RECEIPT DATE: 5/27/2026 **ONSITE SEWAGE DISPOSAL SYSTEM**

APPROVAL DATE: 6/23/26 **PERMIT: REPAIR**

PROPERTY ADDRESS: 685 Watersville Road Mt Airy MD 21771

685 W. Watersville Rd - Septic install

TRENCH/DRAINFIELD DATA

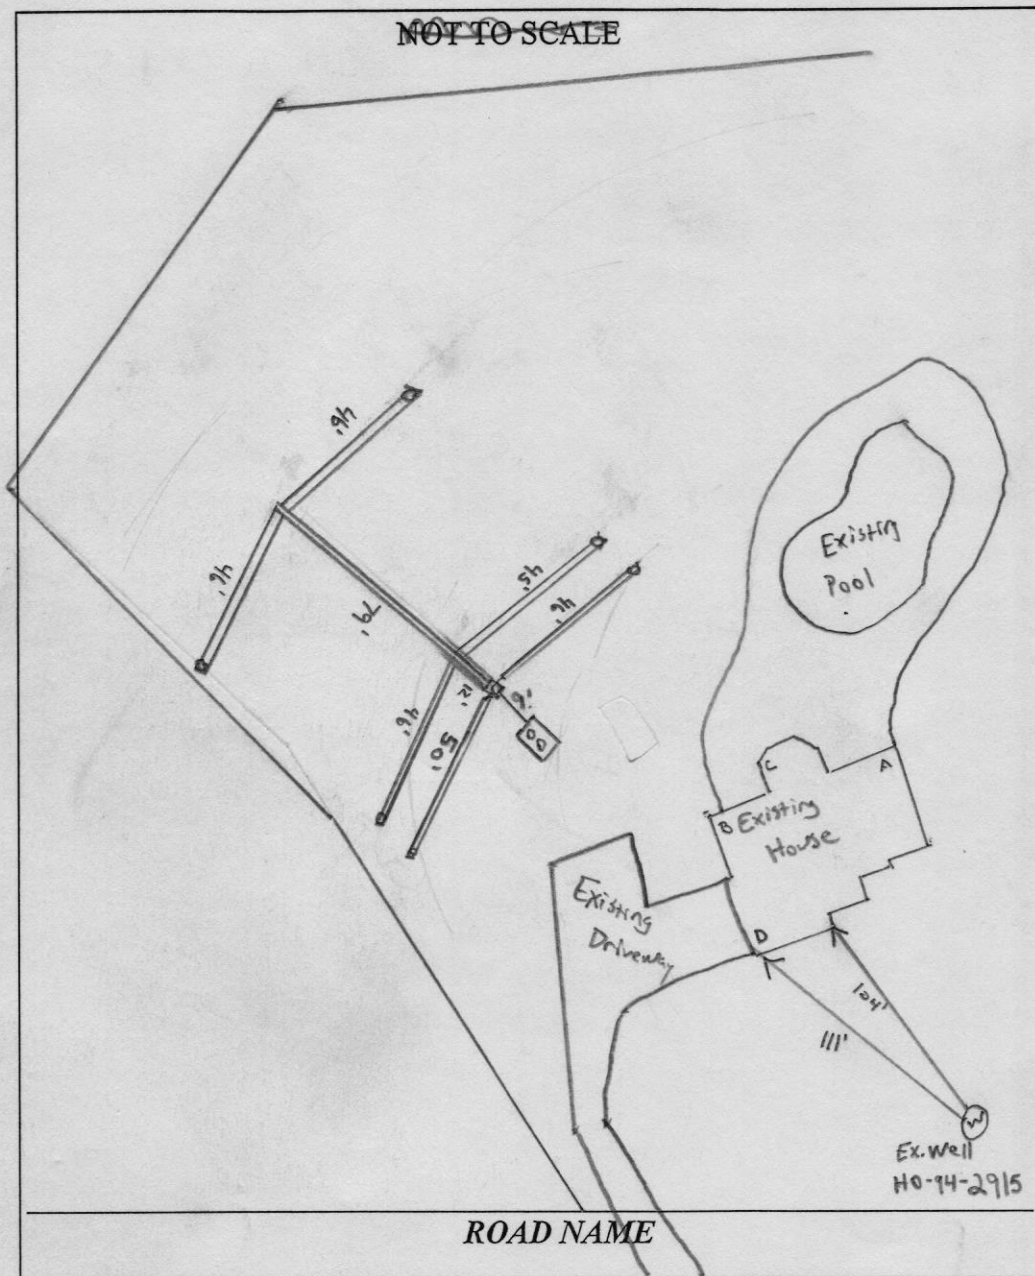
6/16/26 On site day after install. Contractor claims they called in for inspection, but inspection not recorded in logbook. Only 1 trench has 46' length per plan. Could not verify inlets of upper 4 trenches. Bottom trench inlets are 3'. Middle trenches covered up, could not verify inlets. Stuck measuring tape down observation ports on middle two trenches and only goes to 7' depth. New d-box installed, needs a baffle. New observation port installed on back of septic tank. Will be out tomorrow to verify findings with Legacy Septic. * Corrective actions needed for trench lengths, geotextile fabric, trench pipe on sides of trench, no baffle in d-box. Stone depths, pipe inlet depths. * (MC)

Installer & plan preparer: George Schooley, Legacy Septic & Excavation LLC

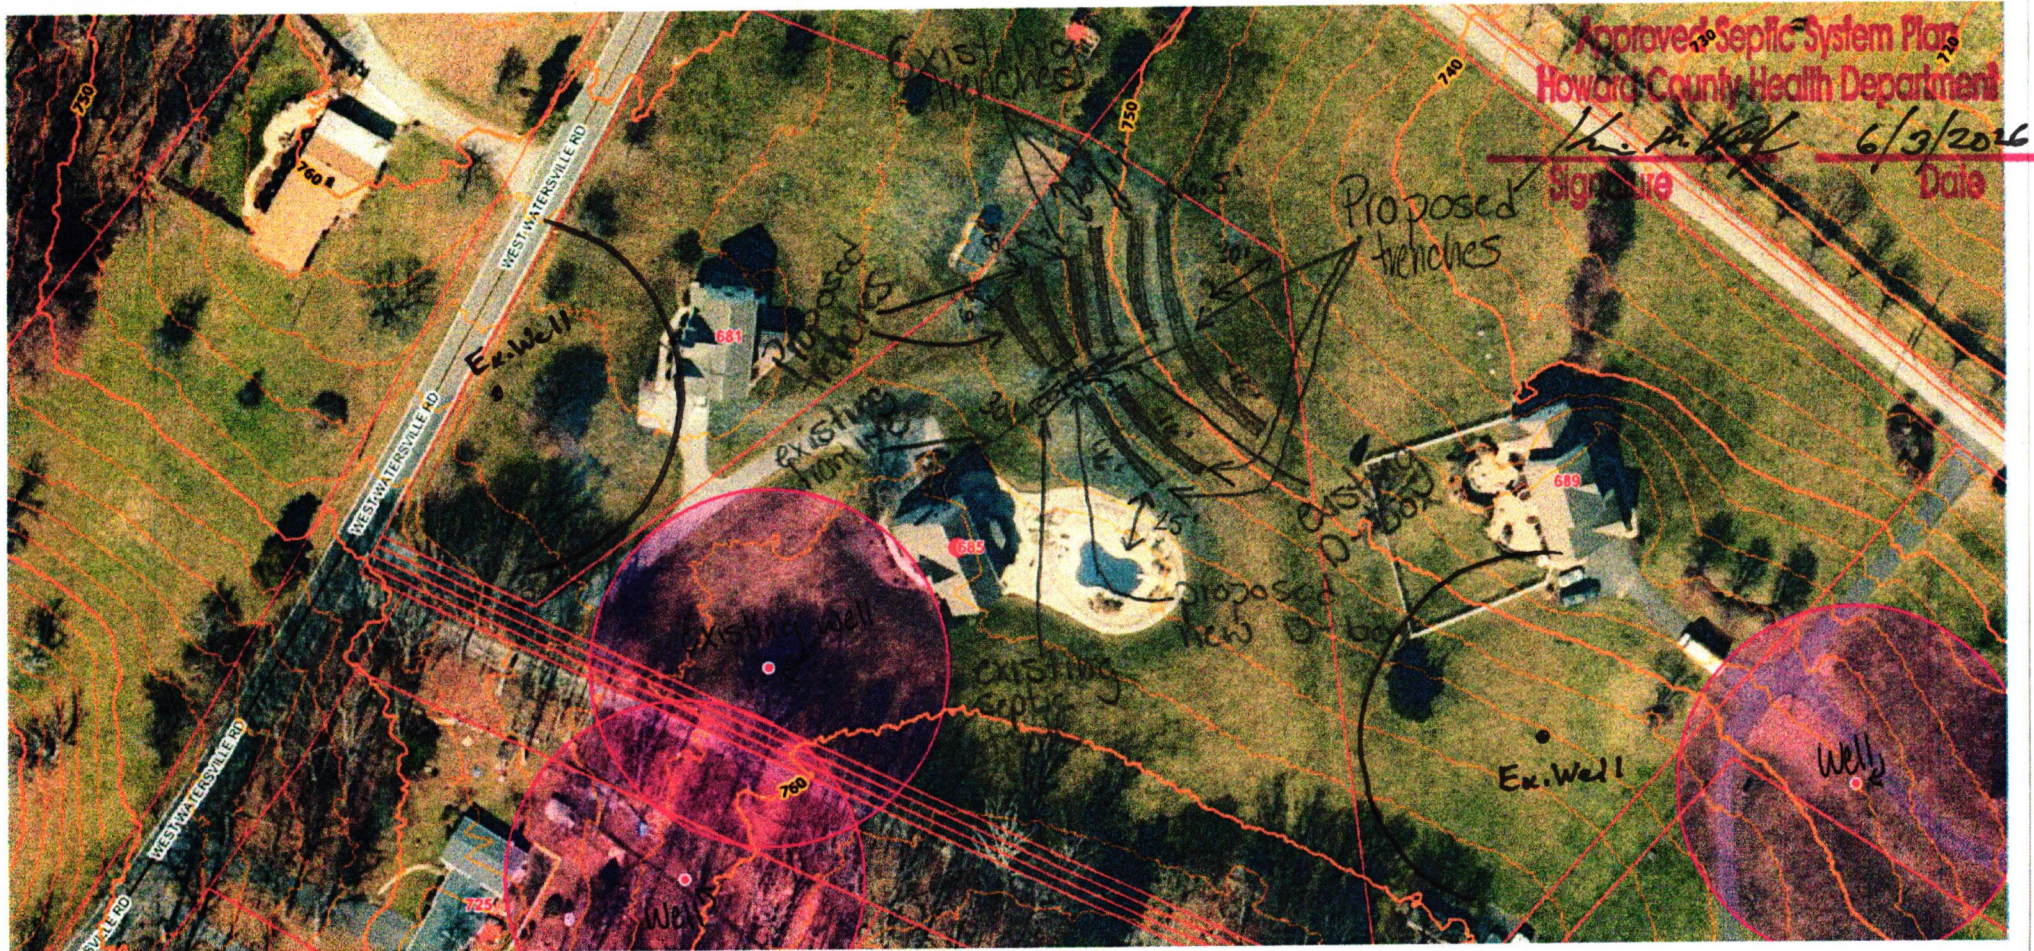
1. The trench pipe installed on four of the six trenches seem to be installed close to the side of the trench. Pipe should be installed in the center of a trench for proper drainage.
2. The geotextile fabric laid overtop of the pipe and stone was bunched in spots. This allows dirt to seep through below the septic pipe.
3. Not adequate stone placed at the beginning and ends of some of the trenches. This could cause the pipe to bow and break.
4. Could not verify trench bottom depth and trench pipe inlet depths. Contractor says he installed per the septic permit plan. Digging up trenches to verify at this point will probably do more damage than good due to the potential for the dirt to mix with the septic stone.

I had the contractor remediate points #2 and #3. He added additional stone, and spot placed geotextile fabric in the trenches where coverage was lacking.

- Stone now placed under and 6" above previously exposed trench pipe.
- Geotextile fabric added over top of spots where previously laid fabric was not completely covering trench.
- Baffle installed in d-box, speed breakers adjusted (MB)
